Device **TC29x**
Marking/Step **ES-BC, BC**
Package **see Data Sheet**

This Errata Sheet describes the deviations from the current user documentation.

Table 1 Current Documentation¹⁾

Figure 3 Message RAM Configurations

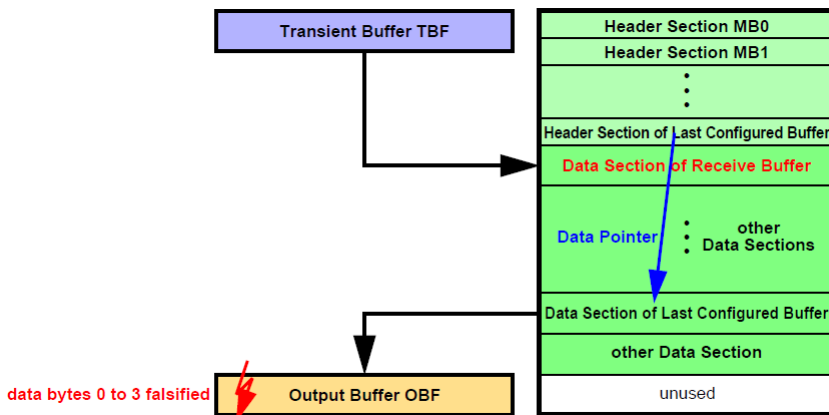
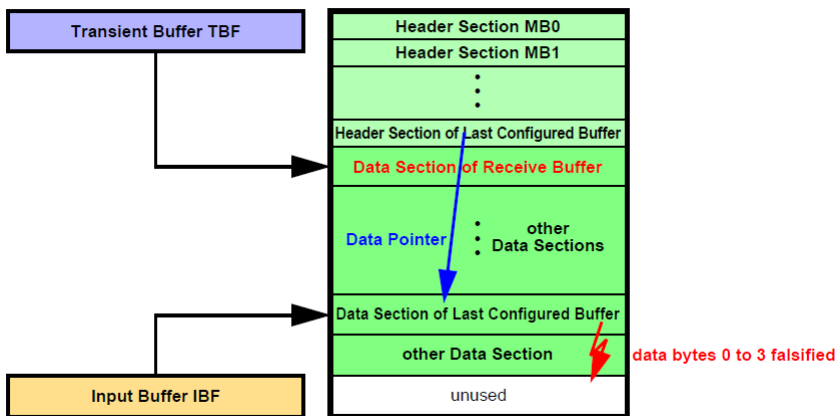
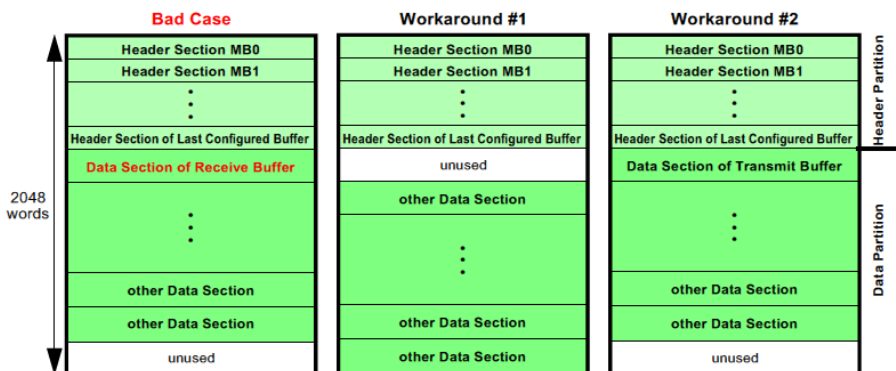
- a) When a message is transferred from the Last Configured Buffer in the Message RAM to the OBF and **PLC = 127** it may happen, that at the end of the transfer the OBF word on address 00h (payload data bytes 0 to 3) is overwritten with unexpected data (see [Figure 1](#)).
- b) When a message is transferred from IBF to the Last Configured Buffer in the Message RAM, it may happen, that at the end of the transfer of the Data Section one additional write access overwrites the following word, which may be the first word of another message's Data Section in the Message RAM (see [Figure 2](#)).

OR

2) Ensure that the Data Section directly following the Header Partition is assigned to a transmit buffer.

Figure 13 SENSITIVITY TOLERANCE of this Design Step

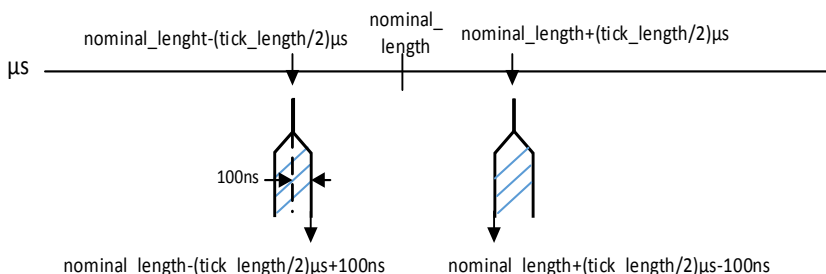
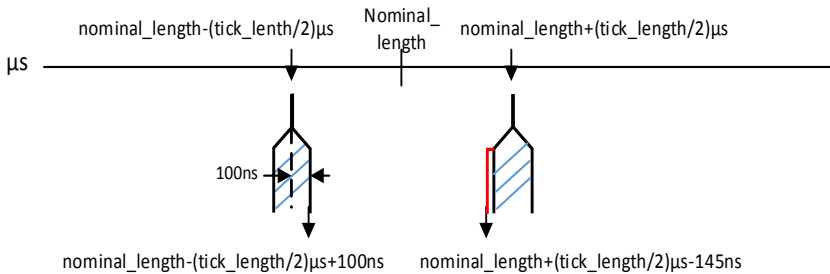
In this design step the range is delimited as follows:

- The lower border is $\text{nominal_value} - (\text{tick_length}/2) \mu\text{s} + 100 \text{ ns}$
- The upper border is $\text{nominal_value} + (\text{tick_length}/2) \mu\text{s} - 145 \text{ ns}$.

Recommendation

Figure 14 Short Serial Message, Serial Data Encoding over 16

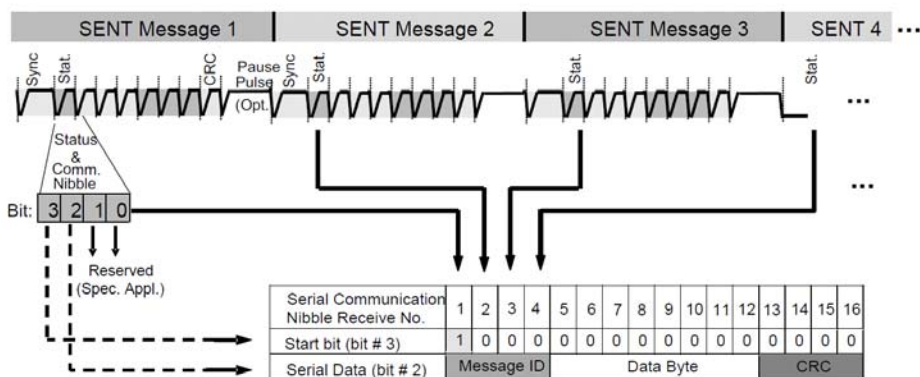
In Figure “Short Serial Message, Serial Data Encoding over 16 messages” of the SENT chapter, the arrows originating from bits 2 and 3 of the Status & Comm Nibble are routed incorrectly and must be swapped.

Figure 14 shows a corrected version of this figure.
